ZO3 SYSTEM BLOCK DIAGRAM

PROJECT : ZO3
Quanta Computer Inc.

Size Document Number Rev 1A
ATHLON64 HT I/F

Size	Document Number	Rev
	MCP67(HT/VGA/FLAT_PANEL)	1A
Date:	Wednesday, April 25, 2007	Sheet 7 of 30

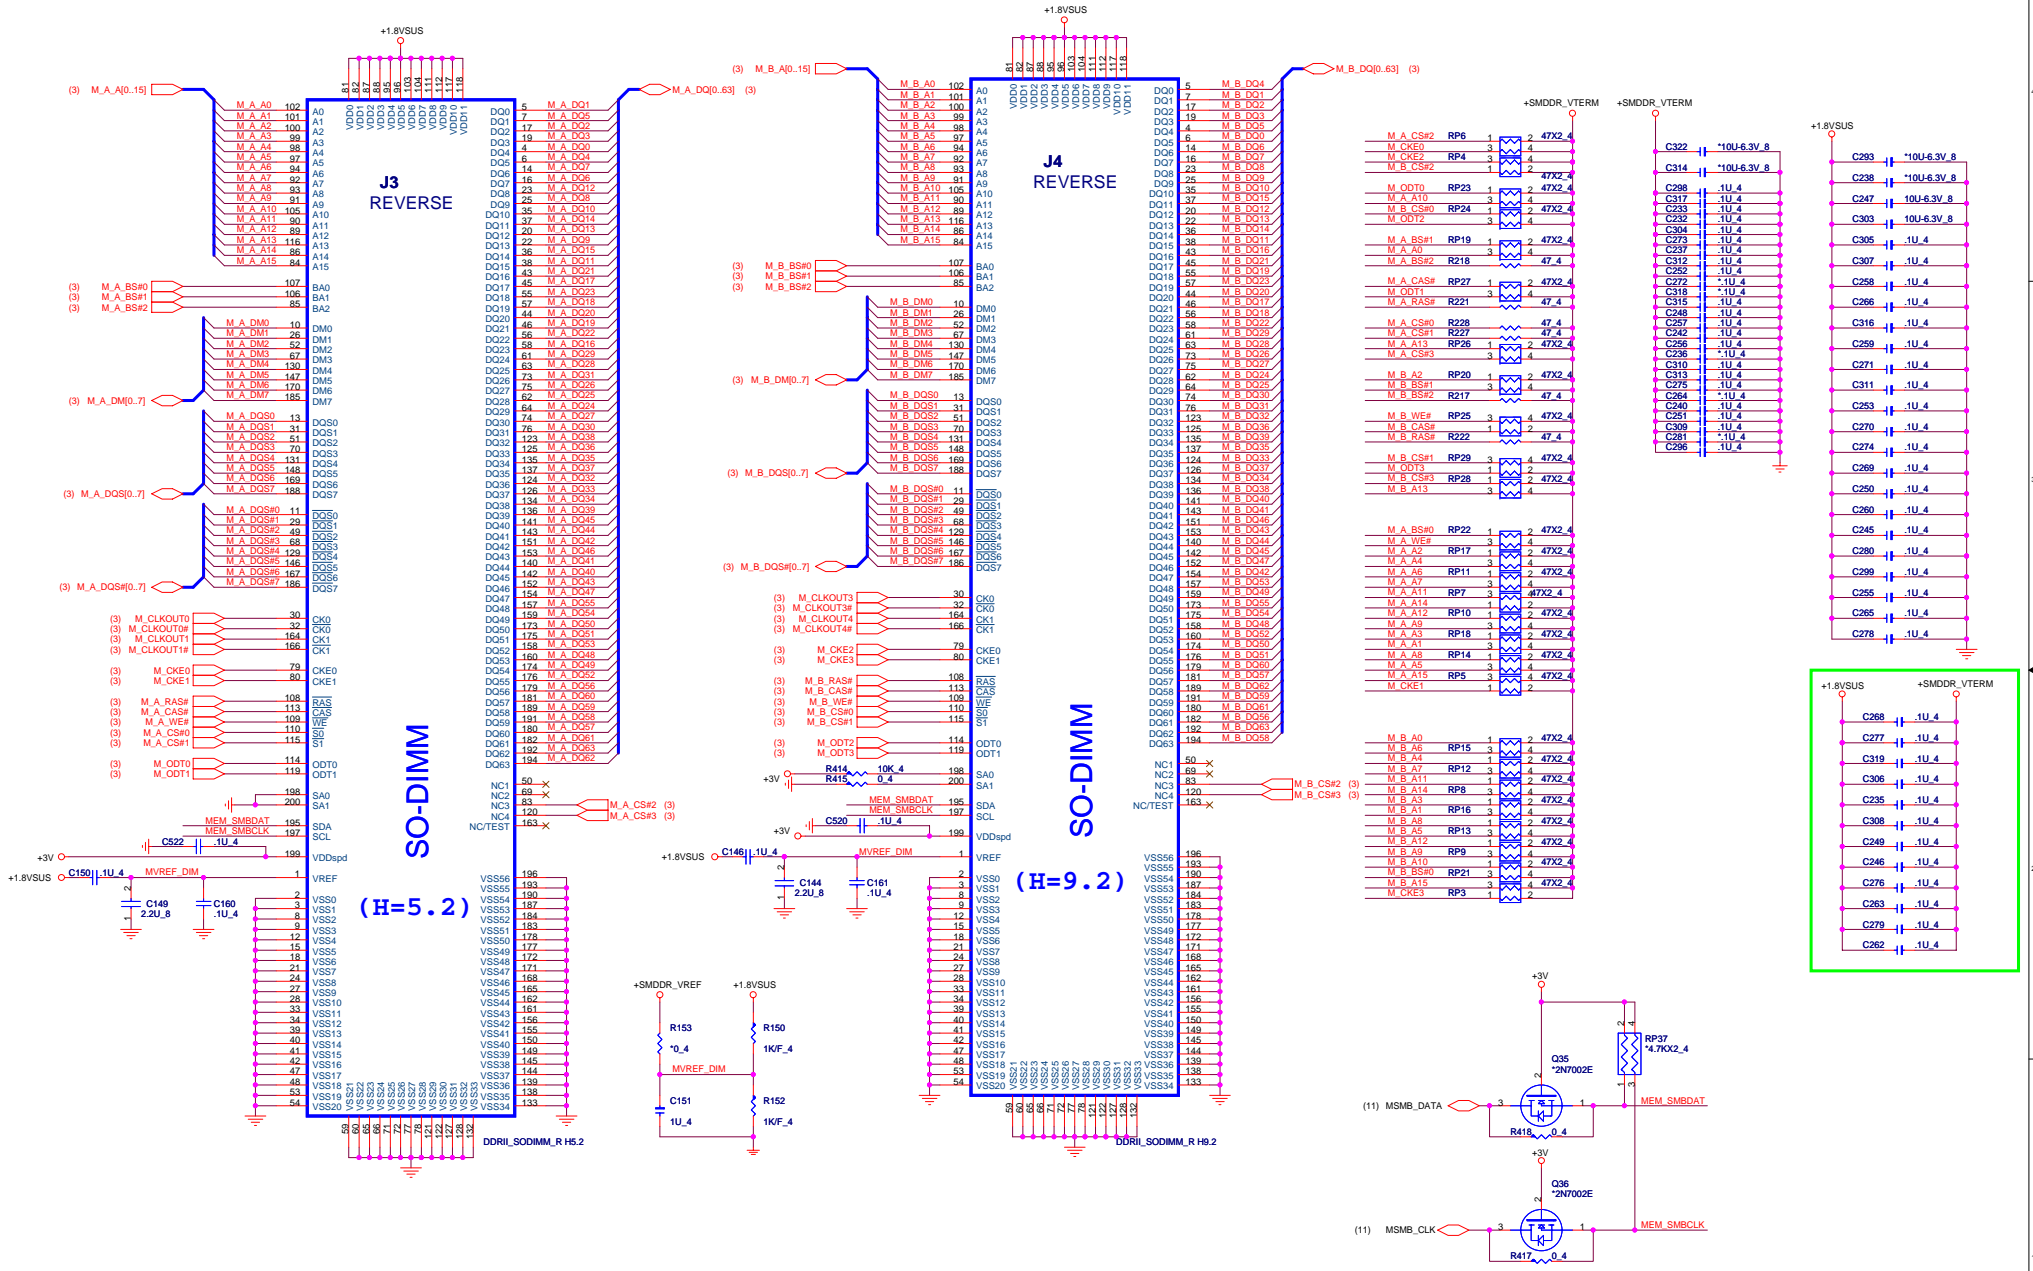
B2B: changed CAP value

C3A: Remove C426, R332 for Nvidia suggest.

C3A: Remove C77, R331 for Nvidia suggest.

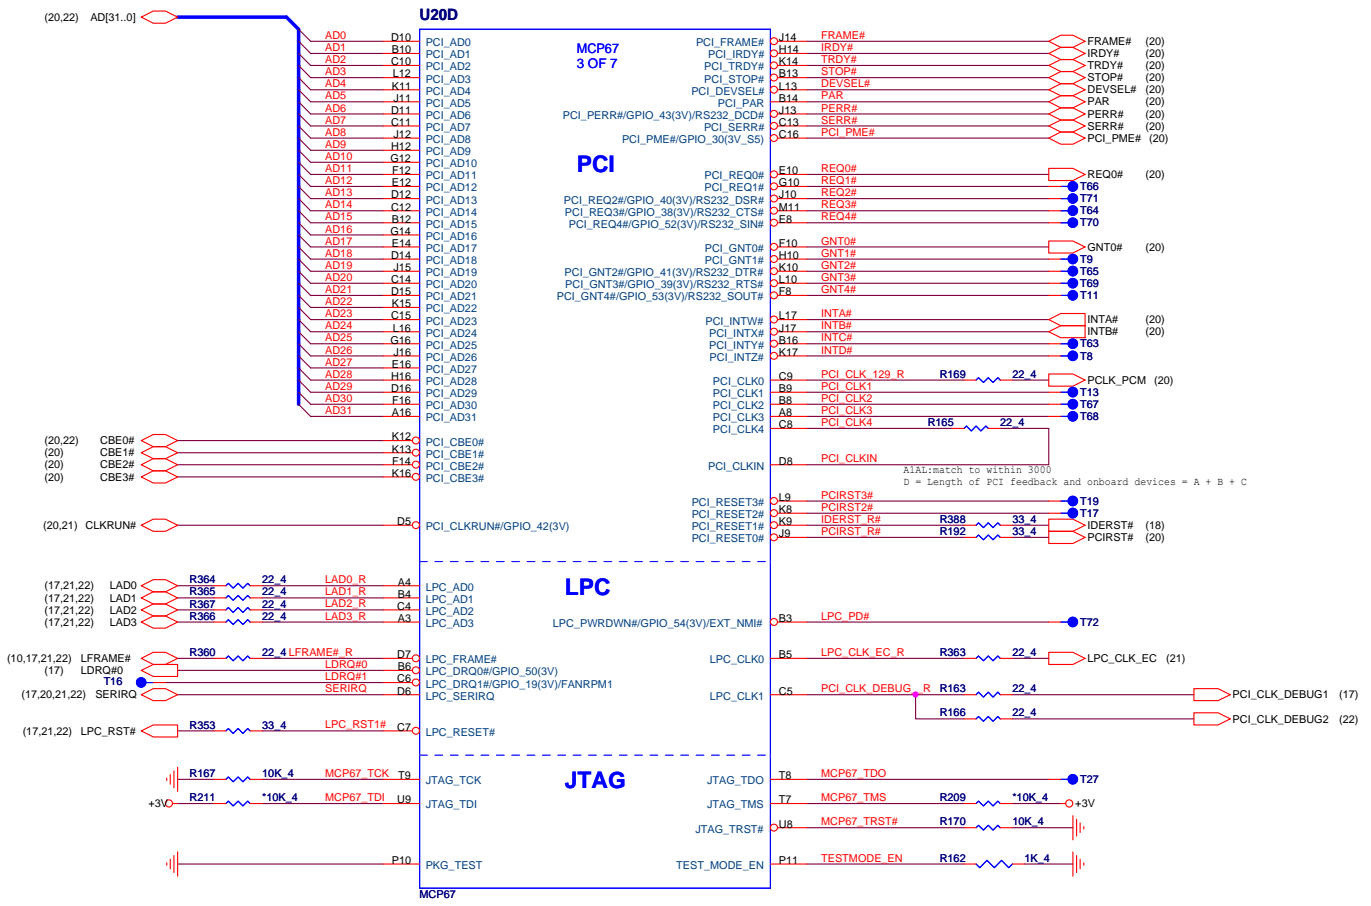
D3B:PIN U24 GO GND DIRECTLY

Add 0R resistor, The resistor should only be stuffed for MCP67D

PCI/LPC PULL-UP

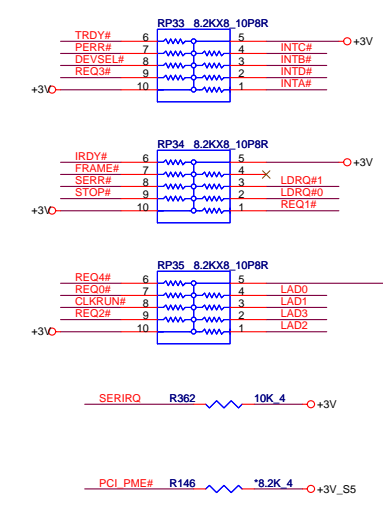
C3A: Remove R116 for Nvidia suggest.

RTC

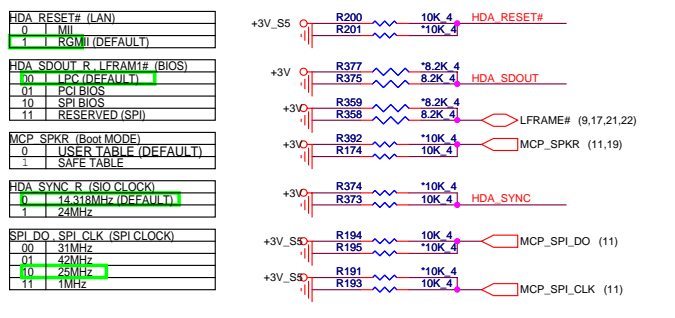
C3A:BCZ timing issue, modify to 22P

MCP67 POWER PLANE/GND & BYPASS

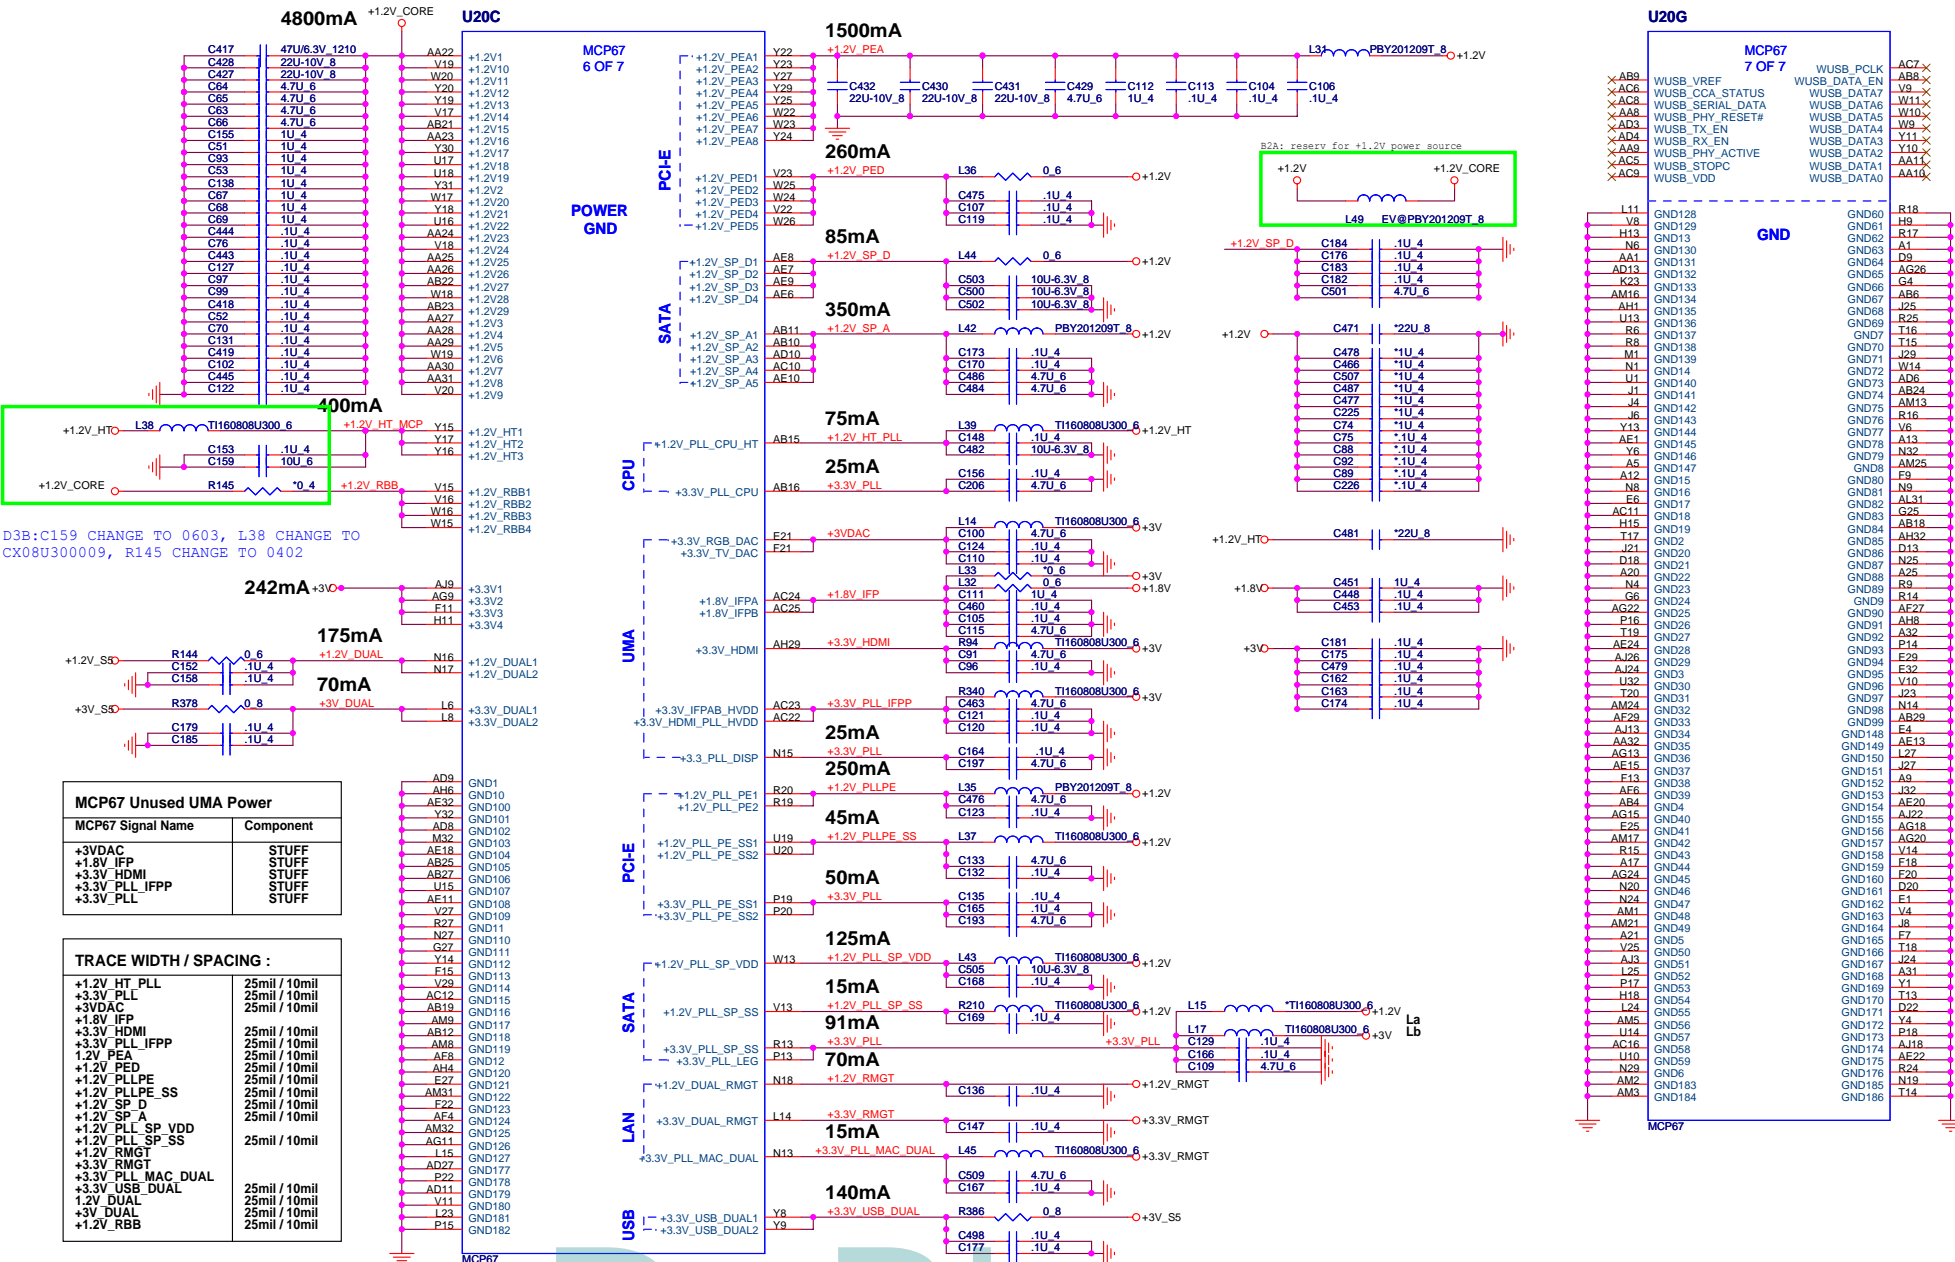
D3B:C159 CHANGE TO 0603, L38 CHANGE TO CX080300009, R145 CHANGE TO 0402

LVDS

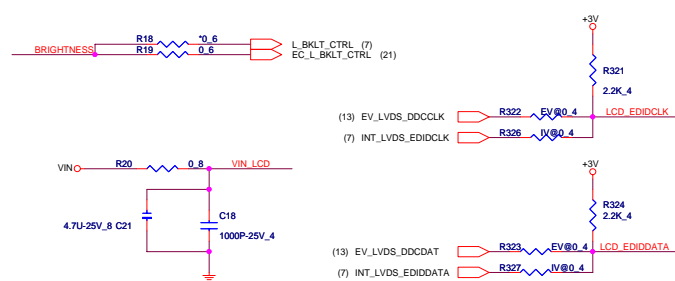
Edison-- 1025 Modify the LVDS pin definition

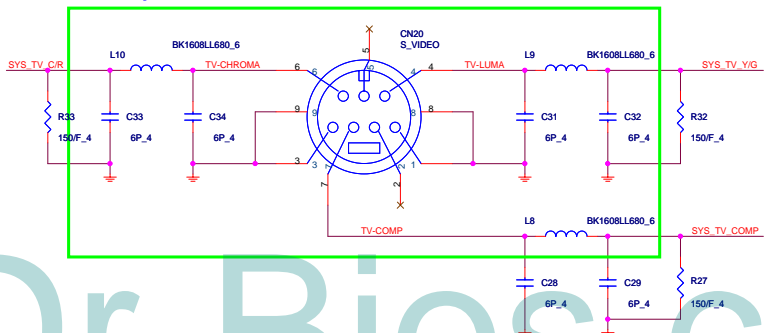
D3B: Change L8,L9,L10 P/N

MINI-Card

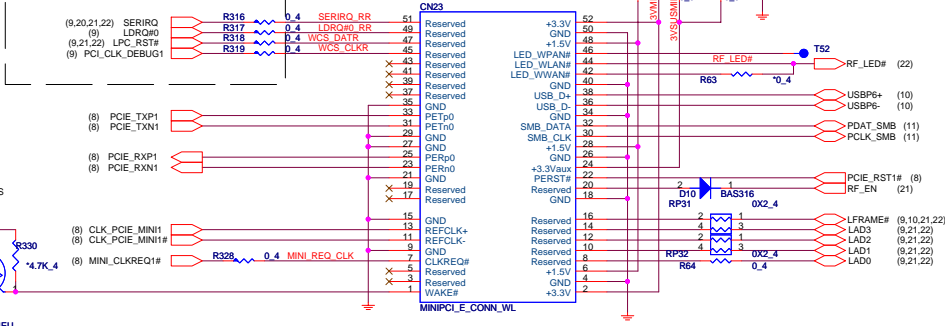
D3B: add C580 for EMI request.

Need reserve 3G pin define
Check Footprint

New card

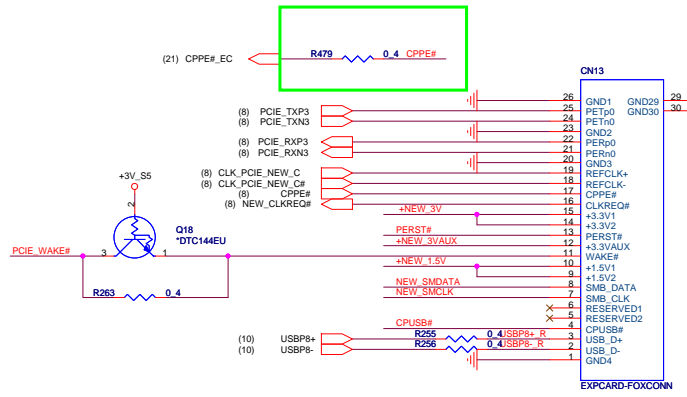
D3B: Add R479 for NEW card CPPE#

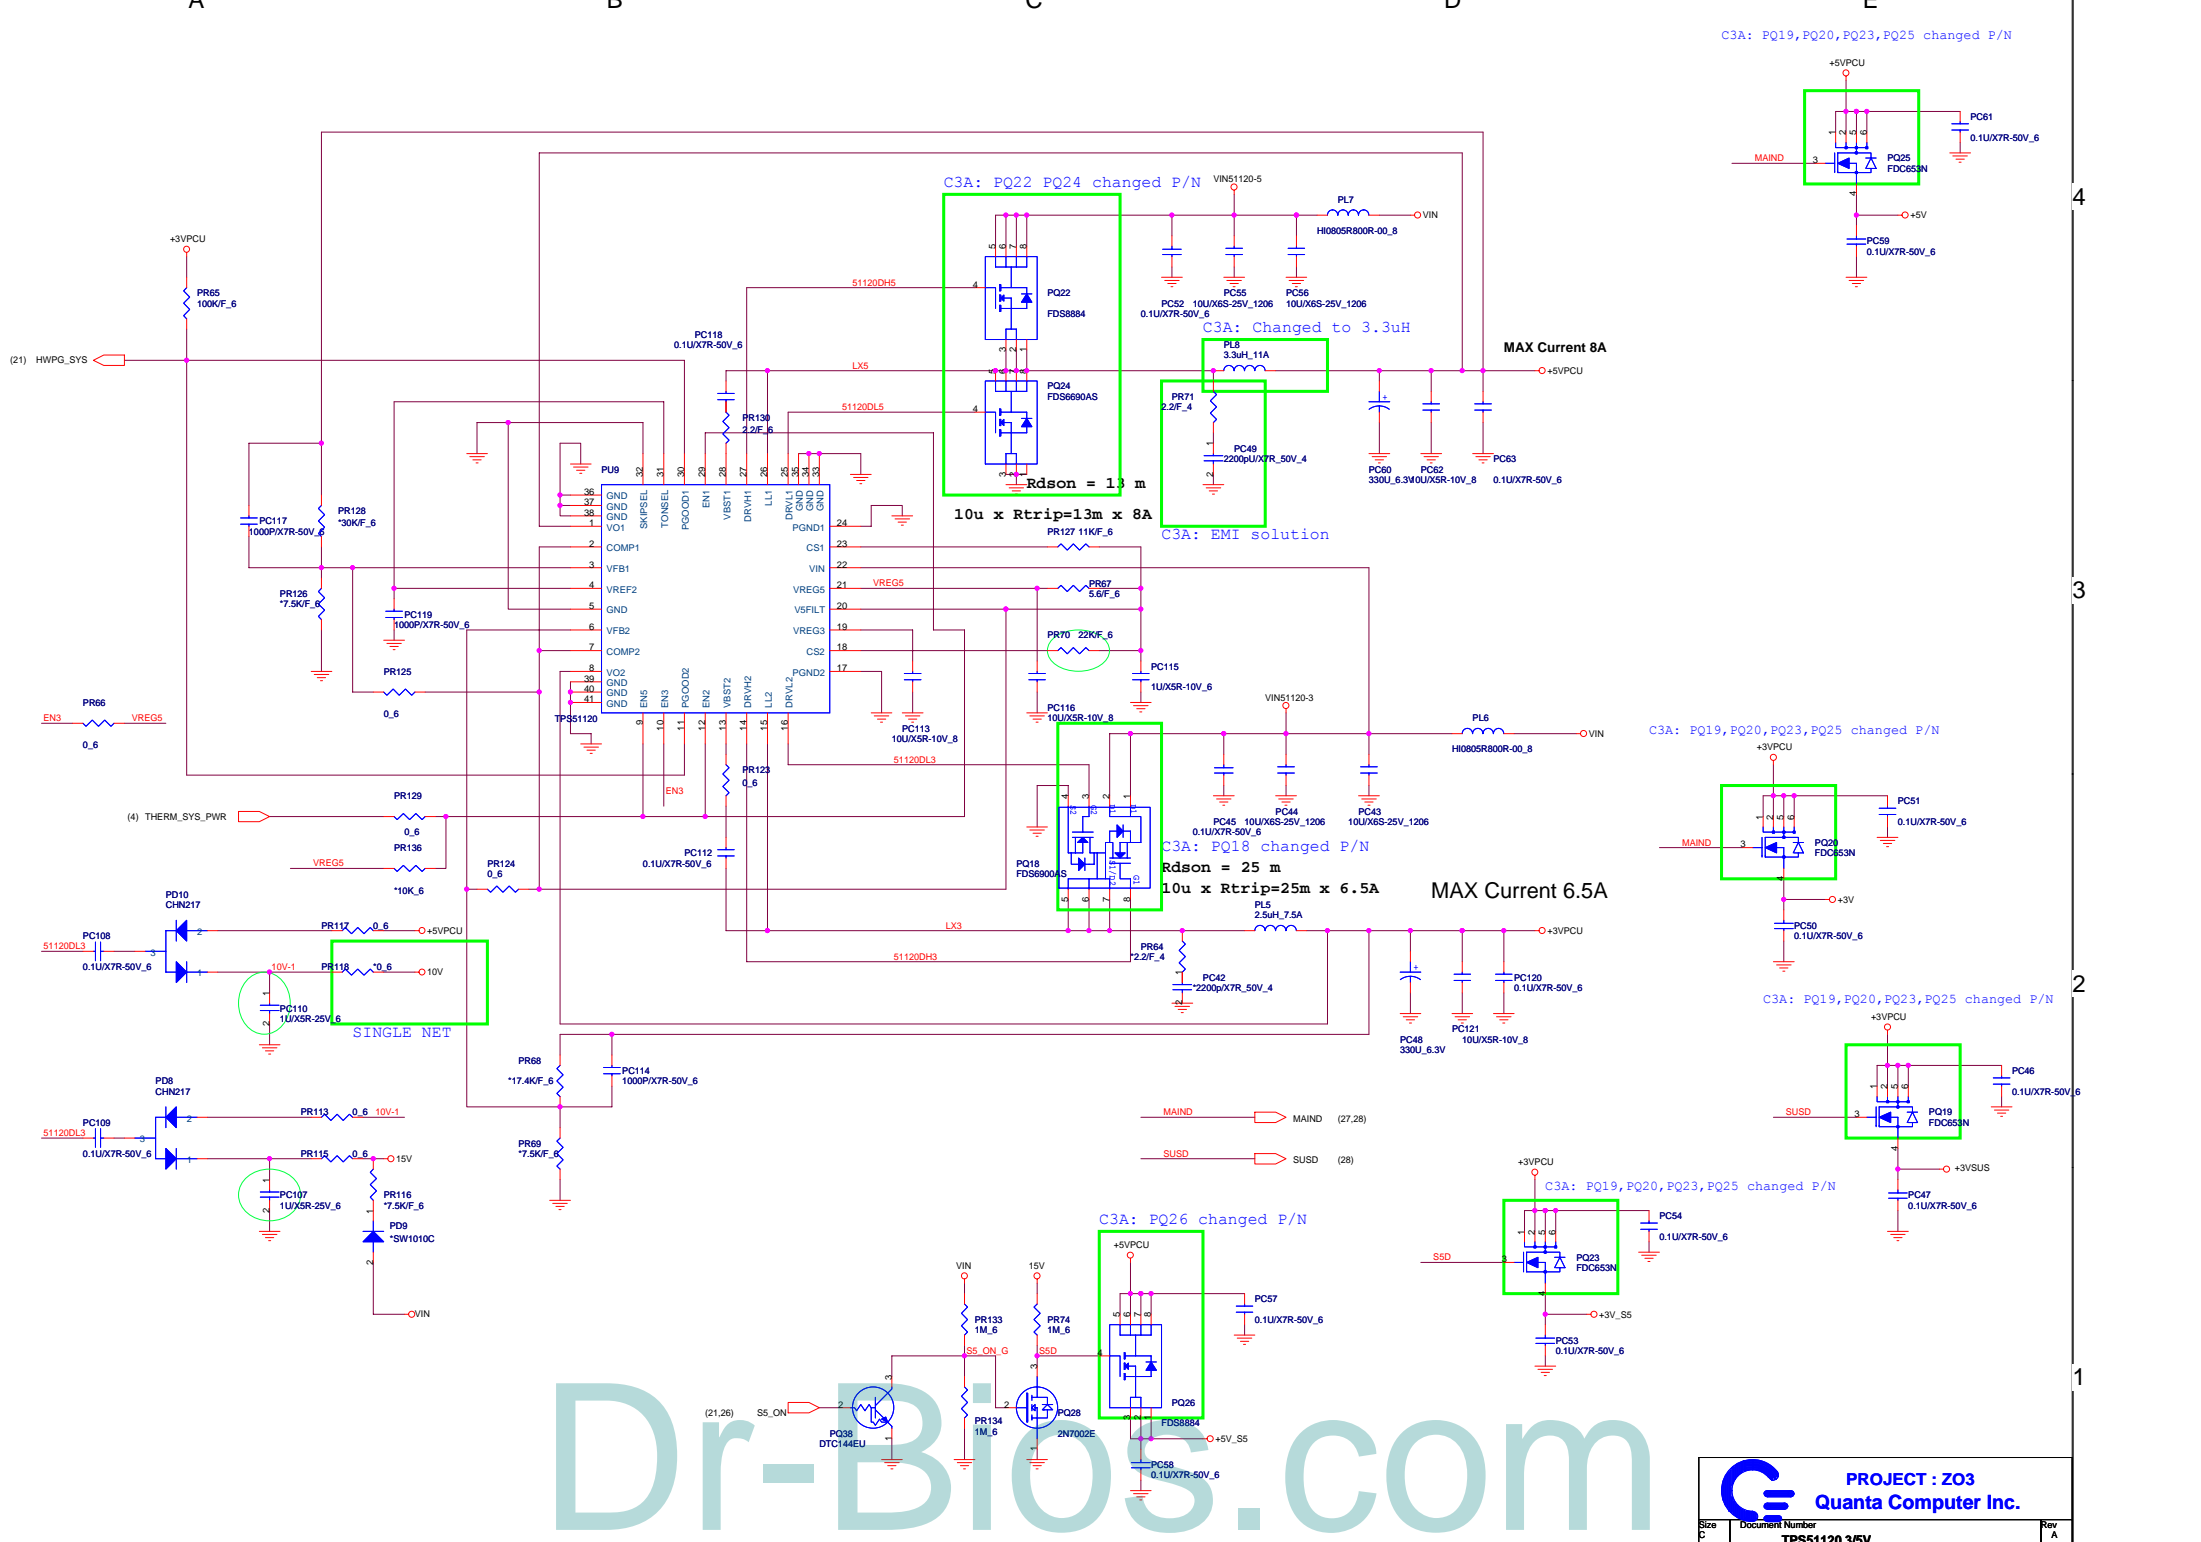
C3A: PQ19, PQ20, PQ23, PQ25 changed P/N

C3A: PQ26 changed P/N
